# Stage 01: Modification Proposal

# GC0101

# EU Connection Codes GB Implementation – Mod 2

## Type B Synchronous Power Generating Modules - General Reactive Capability

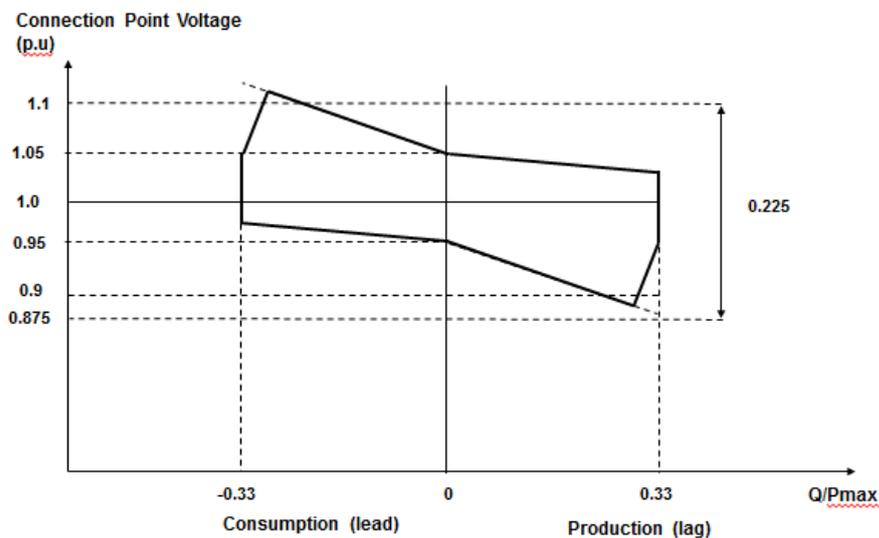
- Reactive capability range of 0.95 Power Factor lag to 0.95 Power Factor lead at Rated MW output at the Connection Point, unless otherwise agreed with NGET or the relevant Distribution Network Operator.
- The value of 0.95 Power Factor Lead to 0.95 Power Factor lag at Rated MW output has been selected on the basis of DNO requirements, general plant capability and equitable treatment with Power Park Modules.

**Voltage/ Reactive Capability diagram for a Type C or D Power Park Module with a Connection Point at or below 33kV (NB most would be Distribution-connected):**

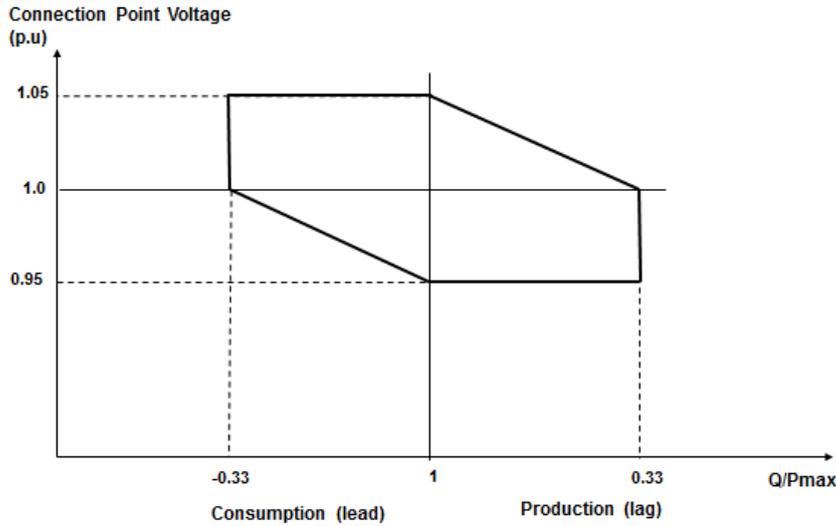
- When operating at maximum capacity, this is defined based on a U-Q/Pmax profile (i.e. a (voltage – reactive power)/Maximum Power Output profile) at the Connection Point.

Figure 8.16(c) –

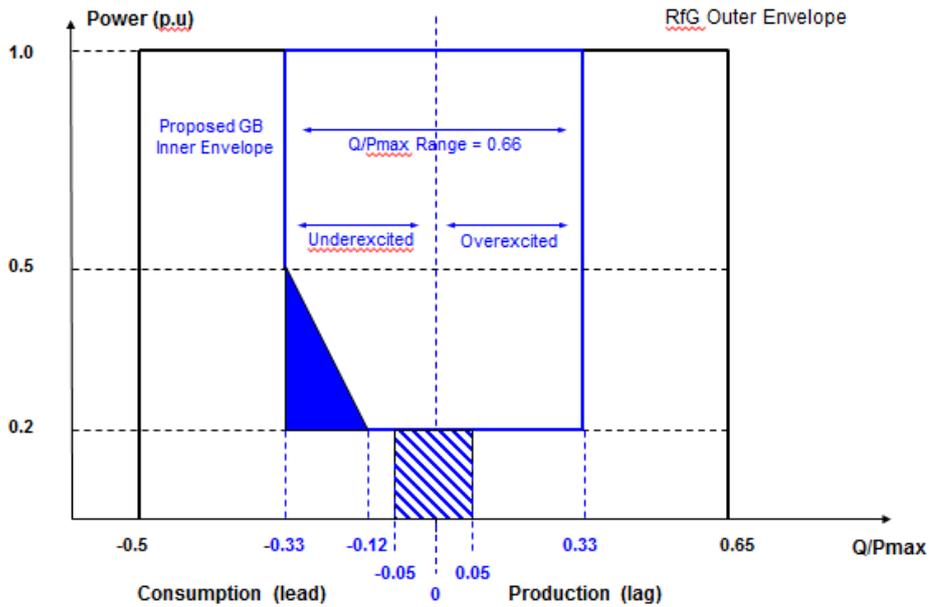
- When operating below maximum capacity, the PPM is required to satisfy a Power – Reactive Power / Pmax ( $P - Q/P_{max}$ ) requirement
- The current reactive capability requirements of CC.6.3.2 can be mapped directly into RfG Article 21(3)(c) other than conversion of Power Factor into  $Q/P_{max}$ . The proposed GB requirement is therefore shown below

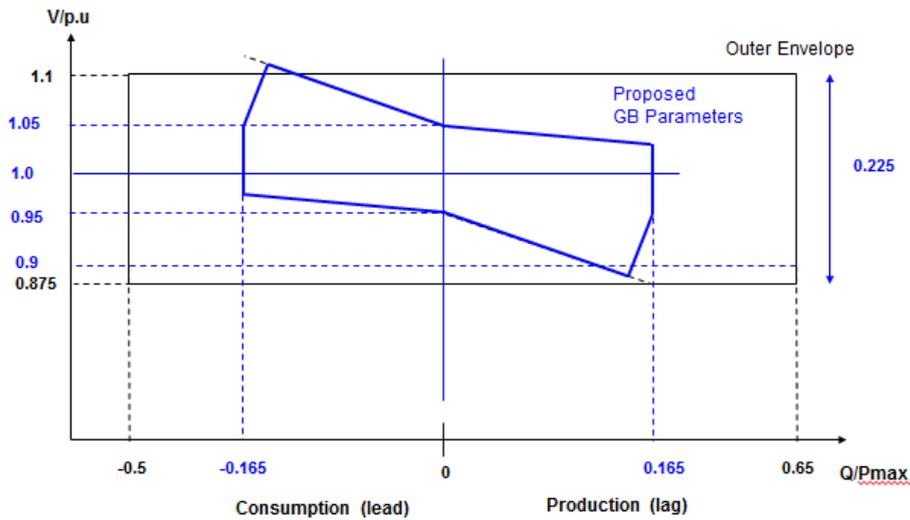
- RfG Article 23 defines the requirements for AC connected Power Park Modules. These are classified into two categories:
  - Configuration 1:- AC connection to a single onshore Grid interconnection point whereby one or more Offshore Power Park Modules that are interconnected offshore to form an Offshore AC System are connected to the Onshore System

- Configuration 2:- Meshed AC connections whereby a number of Offshore Power Park Modules are interconnected Offshore to form an Offshore AC System and the Offshore AC System is connected to the Onshore System at two or more Grid Interconnection Points.
- For any Power Park Module which is connected to an HVDC System, the requirements of the HVDC Network Code shall apply.

## Configuration 2 - AC connected Offshore Power Park Module P-Q/Pmax Profile

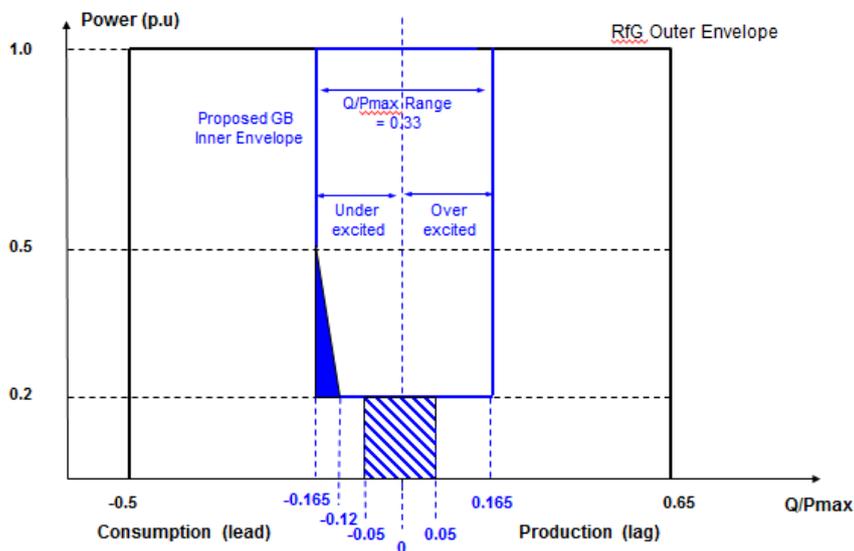
- The Reactive Capability requirements for AC connected Offshore Power Park Modules are broadly the same as those for Type C and Type D Onshore Power Park Modules as defined in Article 21(3), other than in respect of the parameters which are redefined in Table 11 of RfG
- For Configuration 1 Offshore AC Connected Power Park Modules the maximum range of Q/Pmax is set to zero (i.e. unity power factor) and for Configuration 2 Offshore AC Connected Power Park Modules the maximum range of Q/Pmax is set to 0.33.
- Both Configuration 1 and Configuration 2 have a maximum steady state voltage range of 0.225pu
- The voltage range remains unchanged at 0.225pu. The following requirements for Configuration 2 AC connected Power Park Modules are shown below
